Report Type: CC Access Report
Reference Number: 21267
Client: St Marys Senior Citizens
Site Address: 29 Swantston Street, St Marys NSW 2760
St Marys Senior Citizens Centre

ACCESS REPORT

Executive Summary and Design compliance statement

This Access Compliance Report is to accompany a DA/CC Application for the development proposed at 29 Swanston Street, St Marys for St Marys Senior Citizens Centre

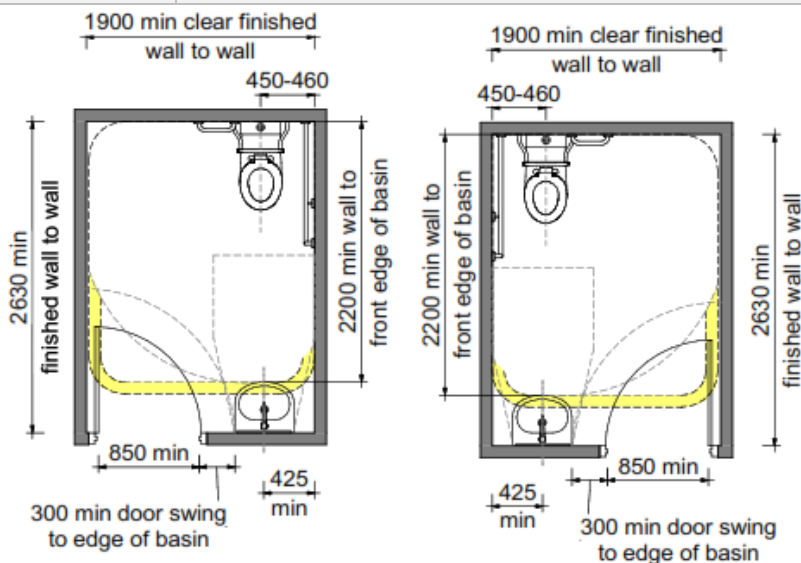
Complies with spatial requirements.
Note minor updates are required to accessible toilet drawings including correct location of clothes hooks.
Requirements are noted as specifications on Architectural plan number MP18302-A005.
